Product Change Notification / SYST-04AEAI643

ERRATA - dsPIC33EPXXXGS70X/80X Family Silicon Errata and Data Sheet Clarification

dsPIC33EPXXXGS70X/80X Family Silicon Errata and Data Sheet Clarification

FIGURE 1:

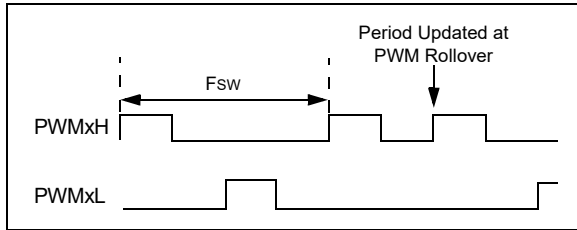
When the PWM module is configured for Push-Pull mode (IOCONx[11:10] = 0b10) with the Enable Immediate Period Update bit enabled (PTCON [10] = 1), a write to the Period register that coincides with the period rollover event may cause the push-pull output logic to produce back-to-back pulses on the PWMx pins (see Figure 1).

Ensure that the update to the PWM Period register occurs away from the PWM rollover event by setting the EIPU bit (PTCON[10] = 1). Use either the PWM Special Event Trigger (SEVTCMP) or the PWM Primary Trigger (TRIGx) to generate a PWM Interrupt Service Routine (ISR) near the start of the PWM cycle. This ISR will ensure that period writes do not occur near the PWM period rollover event.

FIGURE 2: EXAMPLE FOR REDUNDANT OUTPUT MODE

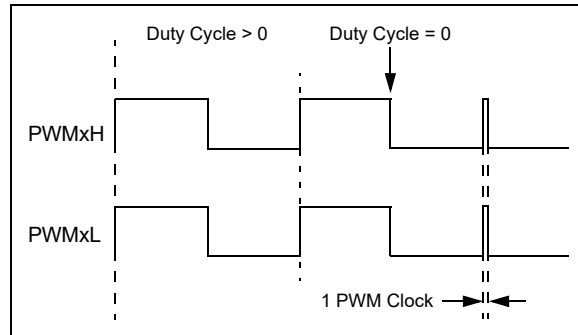
In the Redundant Output mode (IOCONx[11:10] = 0b01) and Push-Pull Output mode (IOCONx[11:10] = 0b10), with the Immediate Update Enable bit disabled (PWMCONx[0] = 0), when the Duty Cycle register is updated from a non-zero value to zero, a glitch pulse of a width equal to 1 PWM clock will appear at the next PWM period boundary, as shown in Figure 2 (for the Redundant Output mode). The Duty Cycle register refers to the PDCx register if PWMCONx[8] = 0 or the MDC register if PWMCONx[8] = 1.

If the application requires a zero duty cycle output, there are two possible work around methods:

1. Use the PWM override feature to override the PWM output to a low state instead of writing to the Duty Cycle register. In order to switch back to a non-zero duty cycle output, turn off the PWM override. The override-on and override-off events must be timed close to the PWM period boundary if the IOCONx register has been configured with IOCONx[0] = 0 (i.e., output overrides through the OVRDAT[1:0] bits occur on the next CPU clock boundary).
2. Enable the Immediate Update Enable bit (PWMCONx[0] = 1) while configuring the PWMx module (i.e., before enabling the PWMx module, PTCON[15] = 1). With the Immediate Update enabled, writes to the Duty Cycle register can have an immediate effect on the PWM output. Therefore, the duty cycle write operations must be timed close to the PWM period boundary in order to avoid distortions in the PWM output.

FIGURE 3: SIMPLIFIED BEHAVIOR

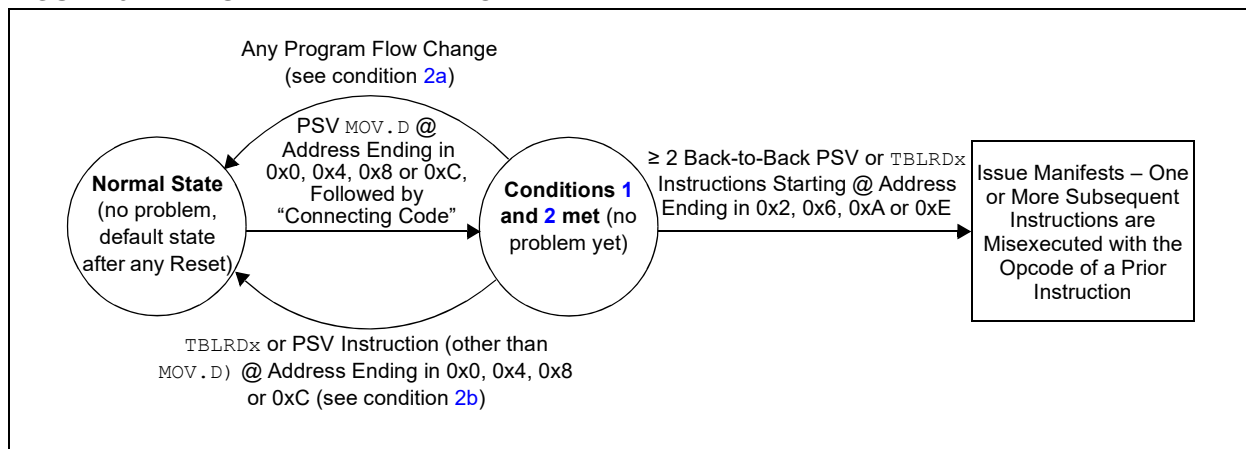
When two or more data Flash read instructions (via Program Space Visibility (PSV) read or Table Read) are executed back-to-back, one or more subsequent instructions can be misexecuted when all of the conditions in [Table 4](#) occur.

[Figure 3](#) provides an example of the effective behavior.

The issue can be avoided by ensuring any one or more of the requirements are not met. For example:

1. All instances of PSV `MOV.D` can be replaced with two PSV `MOV` instructions instead. Non-PSV `MOV.D` instructions acting on RAM/SFRs do not need to be modified; or
2. If not already present, a program flow change instruction (such as `BRA $+2`) can be inserted above back-to-back data Flash read sequences; or
3. Back-to-back data Flash read instruction sequences can be broken up by inserting a non-Flash read instruction (such as a `NOP`), in between the Flash read instructions; or
4. The alignment of the code can be shifted to avoid the required opcode location addresses.

FIGURE 4-2: PROGRAM MEMORY MAP FOR dsPIC33EP128GS70X/80X DEVICES

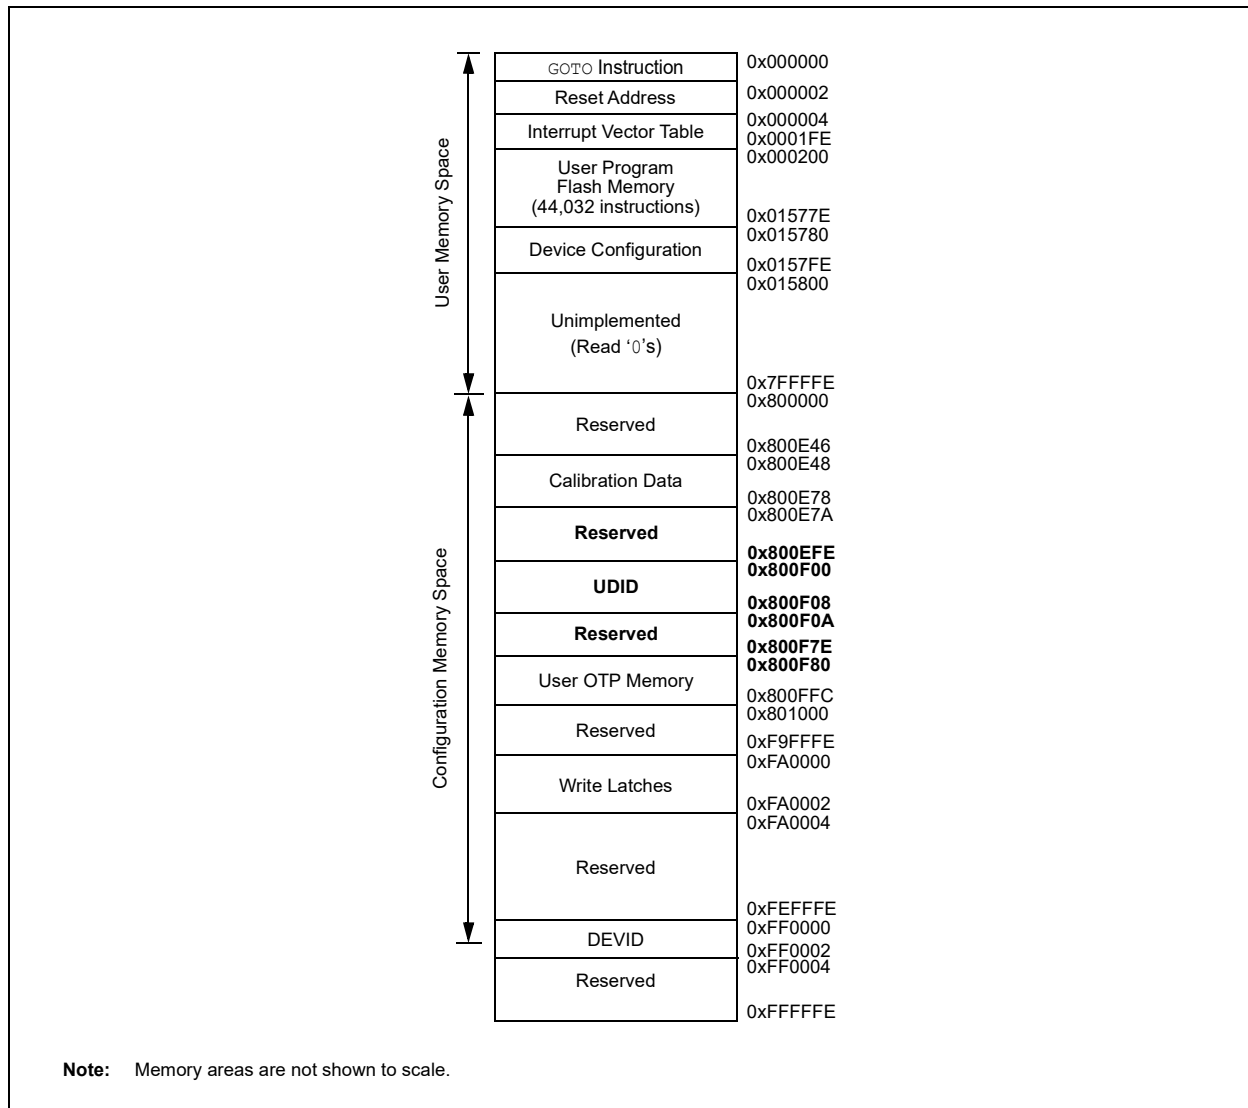
In Figure 4-2, the following changes have been made as shown in **bold**:
